Ref 2026 – 1c – 4b Hampstead Hill Gardens

Re: 4b Hampstead Hill Gardens

I have accessed the Camden Council Planning Portal to review the documents posted for the planning application to demolish and rebuild 4b Hampstead Hill Gardens, as instructed, to carry out a structural review of the proposal.

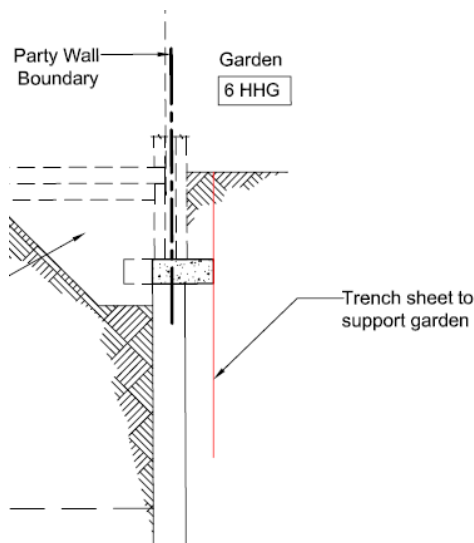
The current Temporary Works proposals show that the existing masonry walls built off the strip footings on the Party Wall line are to be retained but cut back to the Party wall line. As these walls retain the ground additional temporary works will be required to allow this to happen. In addition, the drawing incorrectly references the size of the piles (300mm) and thickness of foundation (225mm) The drawing also indicates that the piles extend significantly below the proposed Basement SSL which is not the case based

on the record drawings, which indicate a toe level at approximately 72.700, as described above.

The cavity wall leaf is to be removed for the full height as noted in the stage drawing and waterproofing is to be provided. This will result in the remaining part of the cavity wall having to resist the wind loads that it has not been subjected to previously and where as one could expect a cavity wall to withstand the wind load on a floor by floor basis this is not the case in this situation. The condition of the wall is not known and nor is the adequacy of any tie in of the wall into the floors which is required to resist any wind load, so the assumption made that no damage will be caused is suspect. This is a major flaw in the planning of the work which will put 4a at risk both during the demolition phase when one leaf is removed but also in the longer term during construction under wind and stability loading for an unknown period of time or season. In addition the construction of the wall below DPC is shown on the record drawings as both cavity and solid construction. To reduce a solid wall thickness by half over a significant length will inevitably create damage to the retained portion of the party wall.
